(Note cursory spot check review not intended to replace QC / QA review of Engineer of Record)

February 3, 2026

Engineer's Report

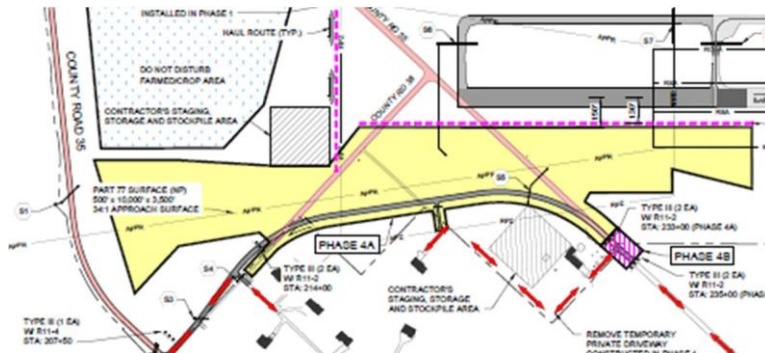
7. Page 39: When calculating a runway's true bearing to determine RWY designation, the nearest epoch year on a 5-year increment should be used. Calculation should be based on 2025 magnetic variation, not 2029. Either way, leave designation at 13/31.

Response: The date was updated to reflect 2025. The rate of change remained the same 0 degrees 4 minutes west per year.
